November 21, 2023

**Subject: CHIQUITA CANYON LANDFILL (SWIS No. 19-AA-0052)  
CALRECYCLE’S REVIEW OF CONDITIONS AT THE LANDFILL  
Response Letter**

**Subject: Review Chiquita Canyon Landfill (19-AA-0052) Response Letter**

Figure 2. The reaction area is shown as pink dashed lines, September 15, 2023.

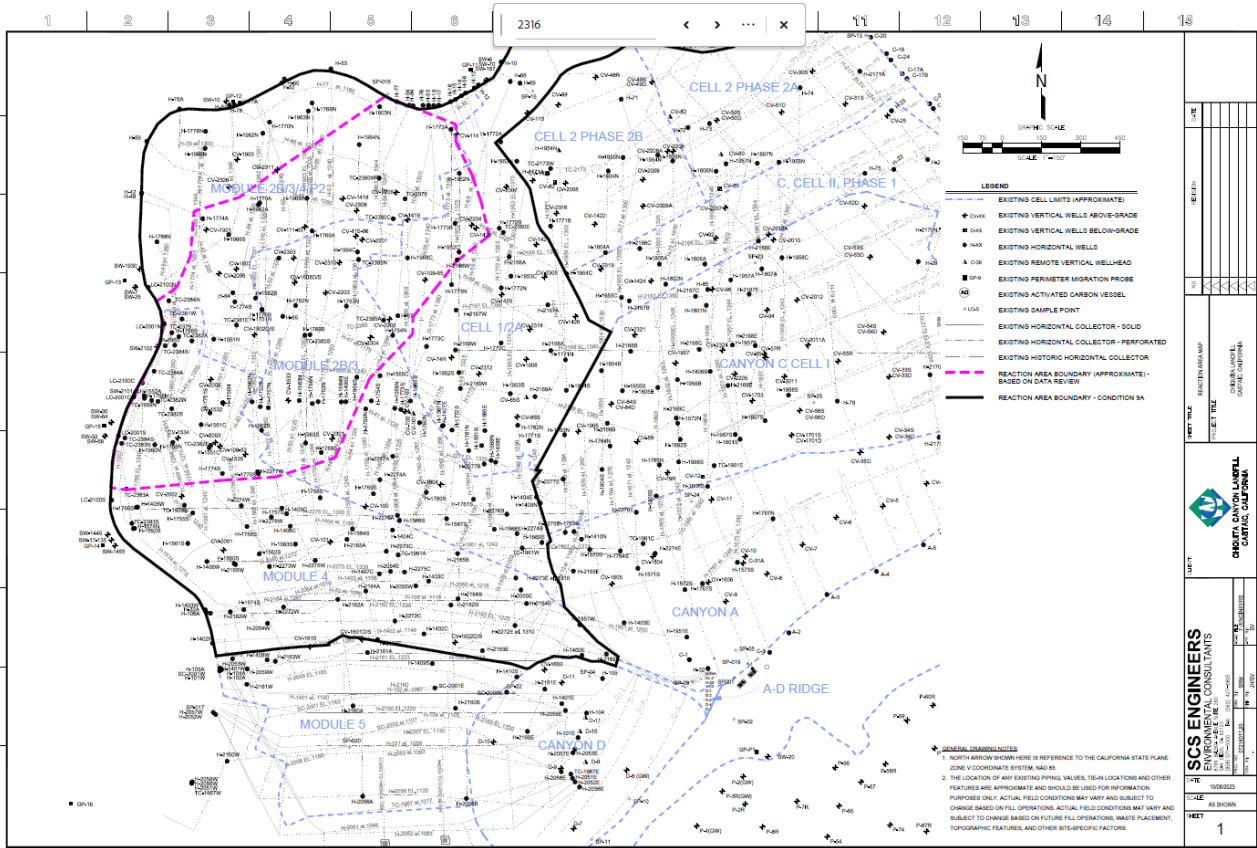
The two CCL reaction site maps from July 2023 and September 2023 show that the incident has expanded in all directions, most notably to the north and west. The approximate size of the incident now is between 30 and 35 acres.
